UNITED STATES PATENT AND TRADEMARK OFFICE

APPLICATION NO.	FILING DATE	FIRST NAMED INVENTOR	ATTORNEY DOCKET NO.	CONFIRMATION NO.
10/617,789	07/14/2003	Kazuto Hirokawa	2003-0960A	4090

Office Action Summary	Application No.	Applicant(s)	
	10/617,789	HIROKAWA ET AL.	
	Examiner	Art Unit	
	Hadi Shakeri	3723

DETAILED ACTION

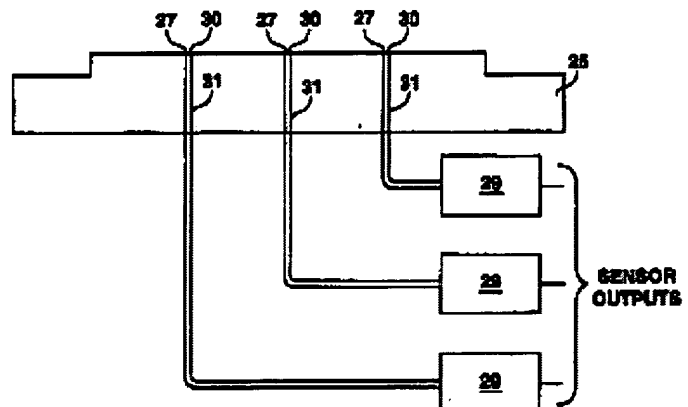
9. Claim 9 (as best understood) is rejected under 35 U.S.C. 102(b) as being anticipated by Pant et al. (5,762,536).

Pant et al. discloses all of the limitations of claim 9, as best understood, i.e., polishing apparatus comprising a polishing table (25) having polishing surface (12) against which a substrate is pressed, light emitting and light receiving devices (optical sensors 29, e.g., 05:57) and first and second passages (31) for introducing fluid through which light passes (e.g., 07:1-11), and a switching "device" for switching between the passages, i.e., (29) (35).

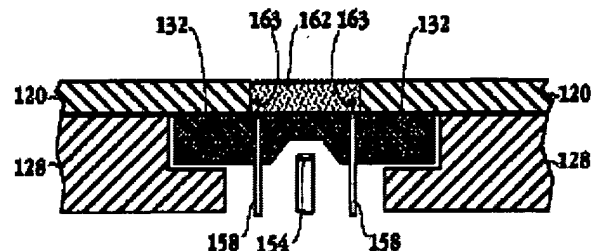
10. Claim 10 is rejected under 35 U.S.C. 102(e) as being anticipated by Boyd et al. (6,599,765).

Boyd et al. discloses all of the limitations of claim 10, i.e., polishing apparatus comprising a polishing table having polishing surface against which a substrate is pressed and a passage (134) to supply a fluid to said polishing surface on said polishing table, wherein said passage includes at least two passages (158), note the explanation above regarding narrative and/or functional language, i.e., each passage may supply high or low flow rate.
